**RE: Town of Kittery, Planning Board Services  
Major Site Plan Review – Review #2  
Rooming House Redevelopment, 17 & 25 Route 236, Tax Map 20, Lot 12 and Tax Map 21, Lot 20  
CMA #591.165**

## CIVIL CONSULTANTS MEMORANDUM

| <b>SUBJECT:</b> | <b>Major Site Plan Review – Review #2<br/>Rooming House Redevelopment, 17 &amp; 25 Route 236, Tax Map 20, Lot 12 and Tax Map 21,<br/>Lot 20 CMA #591.165</b> |              |                        |              |                   |

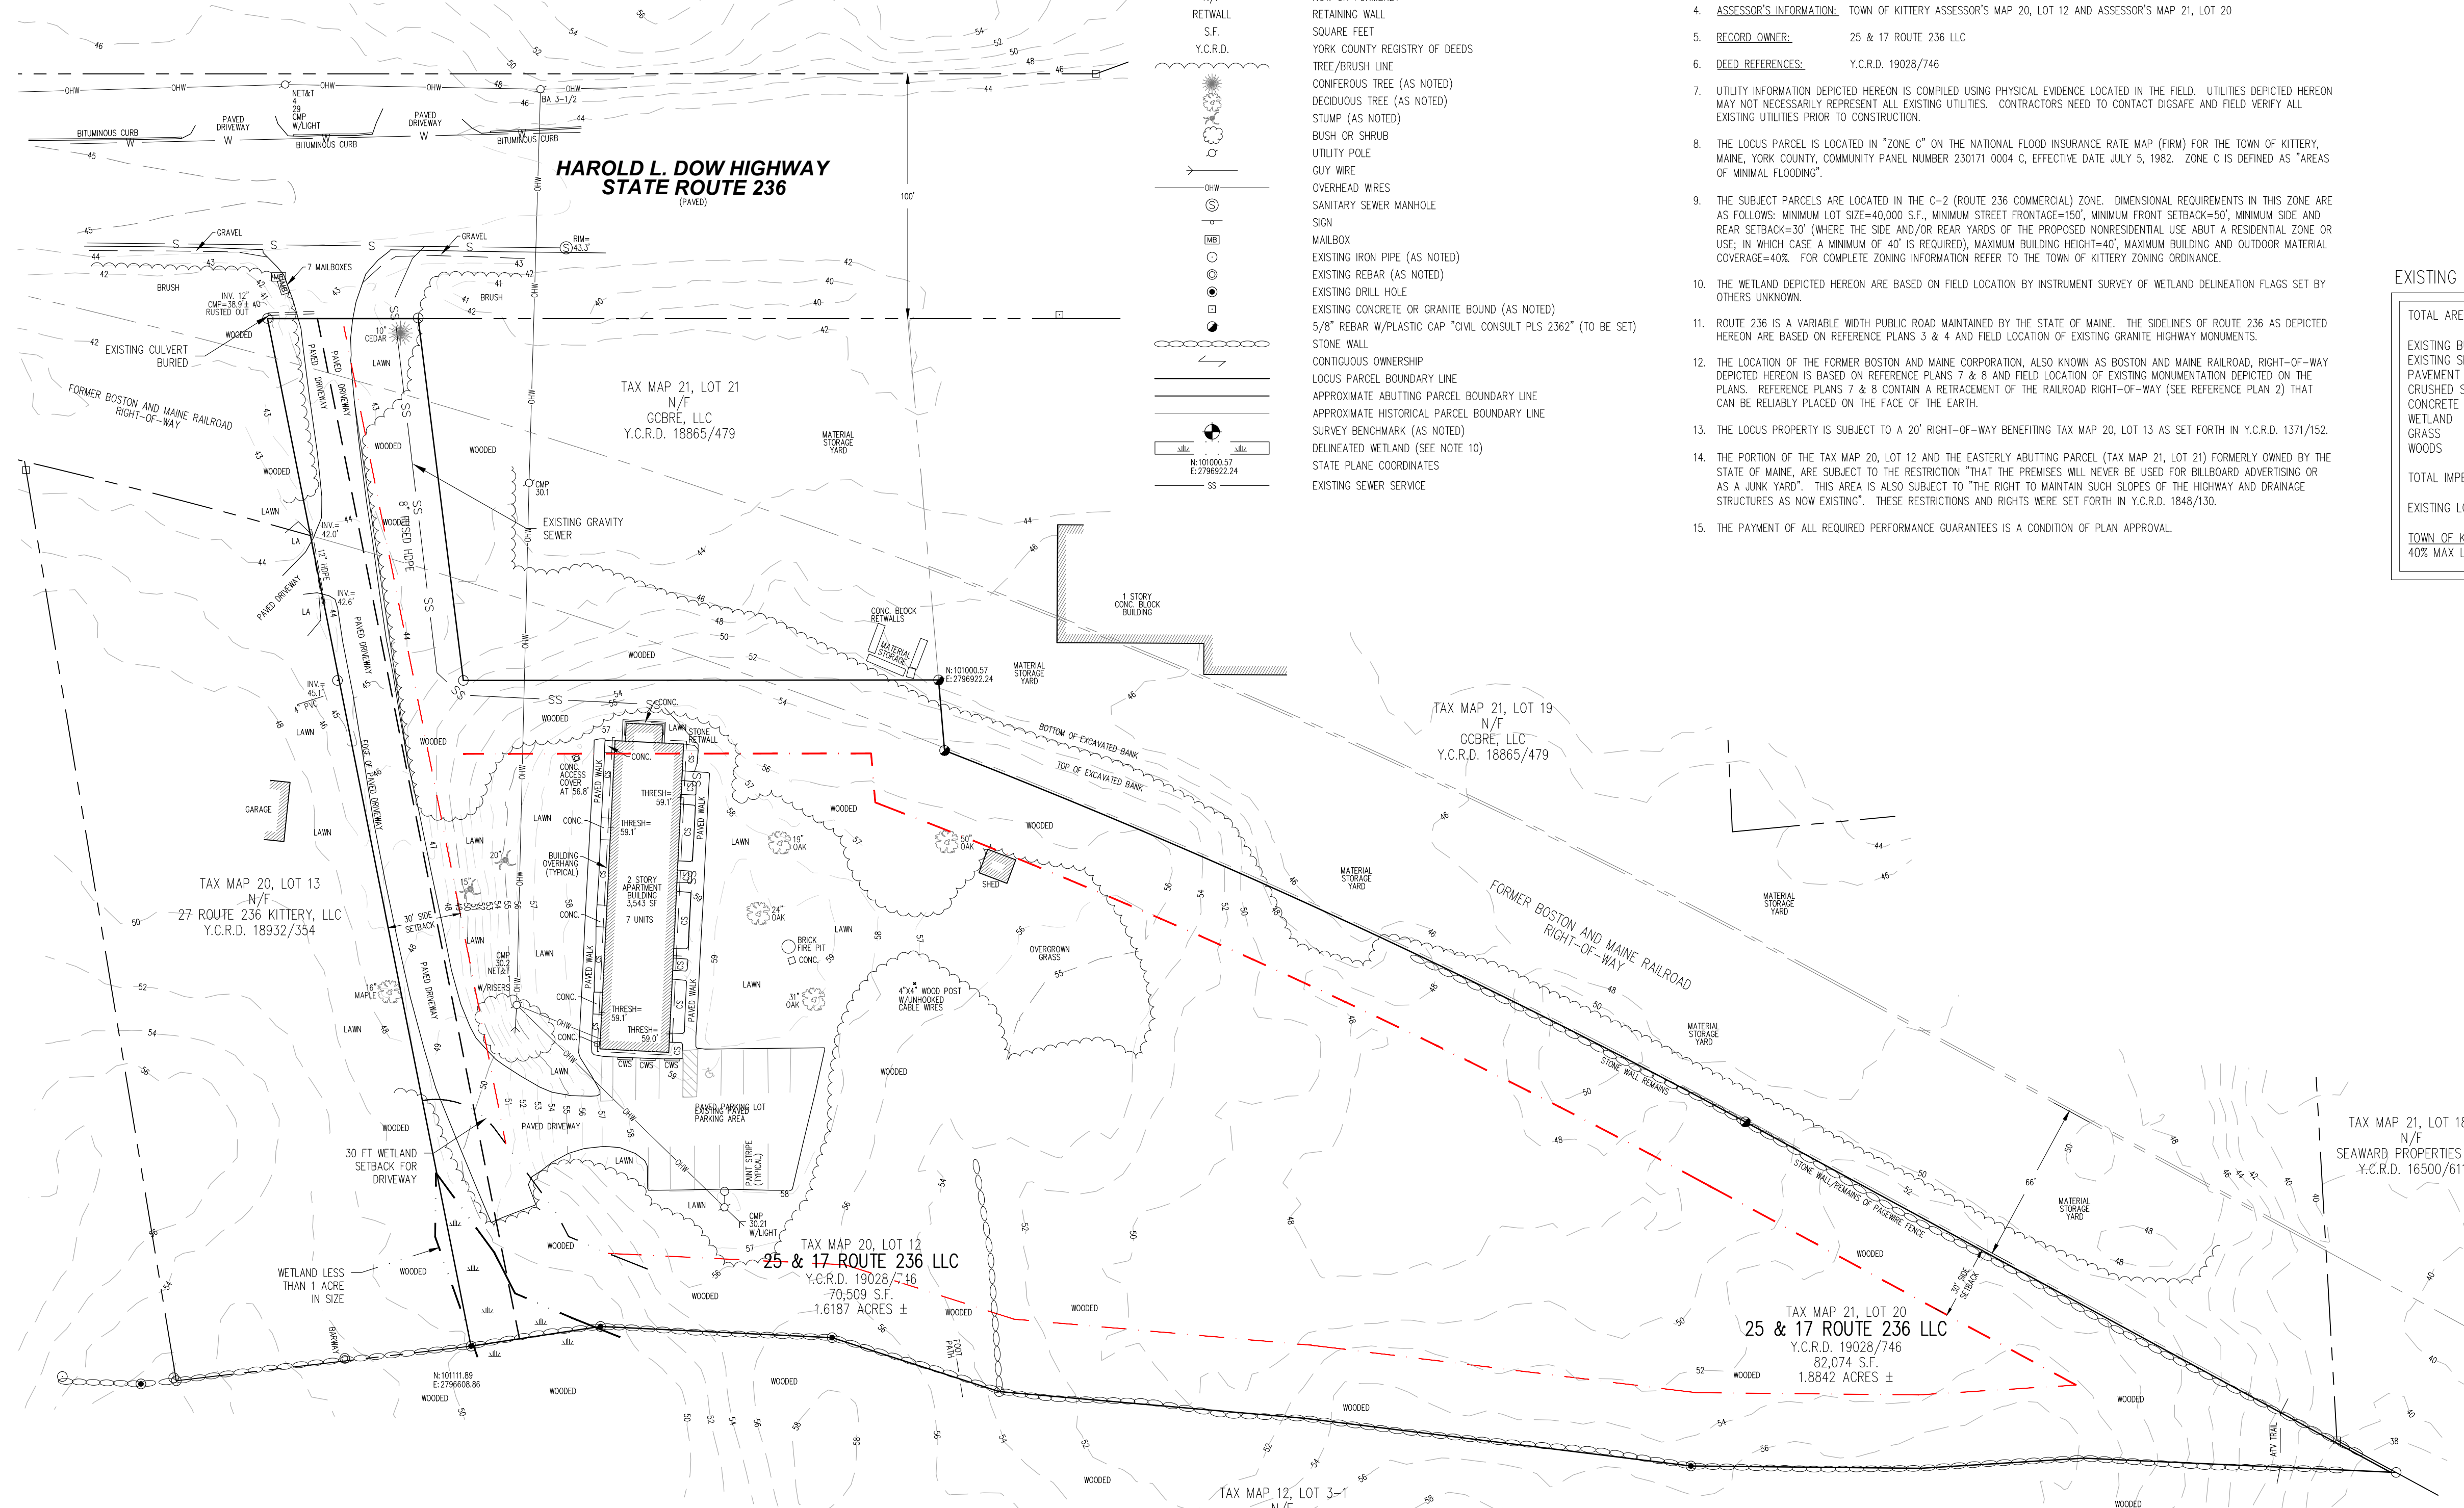
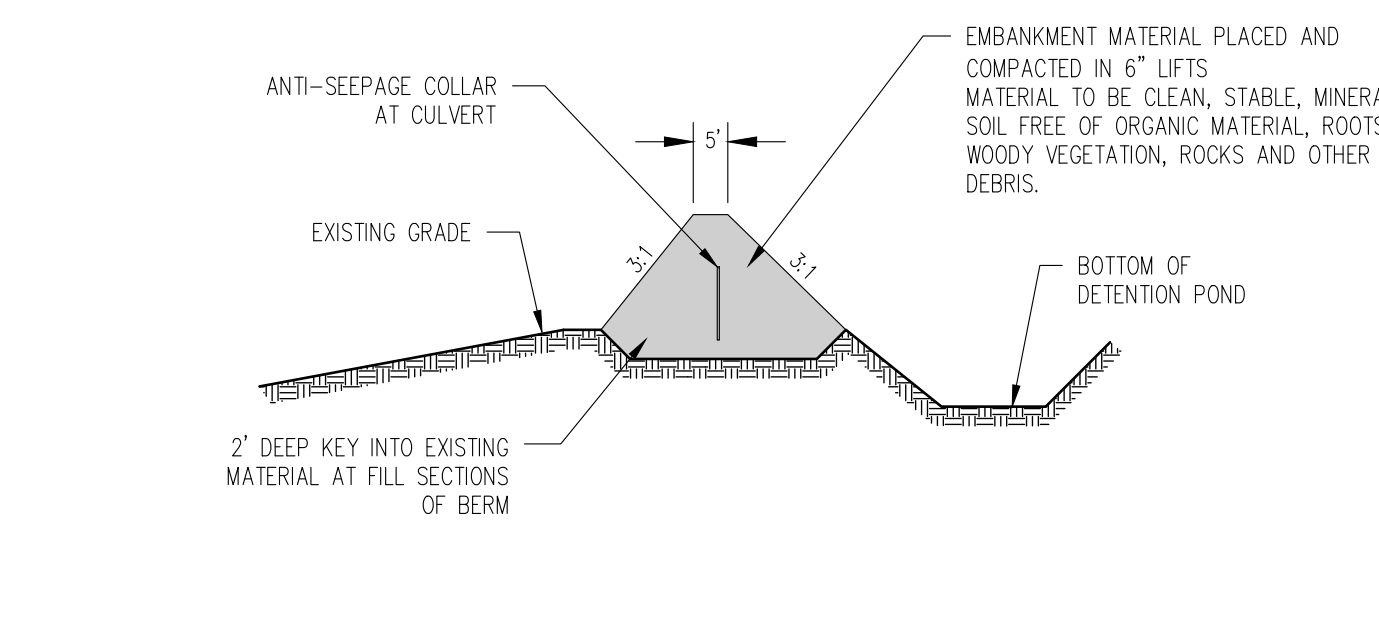
1. The applicant has indicated that an added sheet, Sheet ECSP, contains all known utility information. This sheet was not provided.
2. The applicant has provided a detail for the detention pond on Sheet L5. Is the overflow weir intended to be below the rim elevation of CB #4?
3. The plans should provide details on the existing on-site sewer components to the extent practicable.

| COMMENT  | RESPONSE   |
|--|--|
| We have the following comments with respect to the site plans. <ol style="list-style-type: none"> <li>1. The applicant has indicated that an added sheet, Sheet ECSP, contains all known utility information. This sheet was not provided.</li> <li>2. The applicant has provided a detail for the detention pond on Sheet L5. Is the overflow weir intended to be below the rim elevation of CB #4?</li> <li>3. The plans should provide details on the existing on-site sewer components to the extent practicable.</li> </ol> | <ol style="list-style-type: none"> <li>1. <i>Please see the attached plan set that has the existing conditions with known utilities.</i></li> <li>2. <i>CB#4 is set higher than the overflow. The intent is to have the overflow control in the extreme condition. The stormwater analysis indicates that the 50 yr storm does not top the proposed overflow.</i></li> <li>3. <i>Please see attached information provided by the Kittery Sewer District pertaining to the existing sewer on the property.</i></li> </ol> |
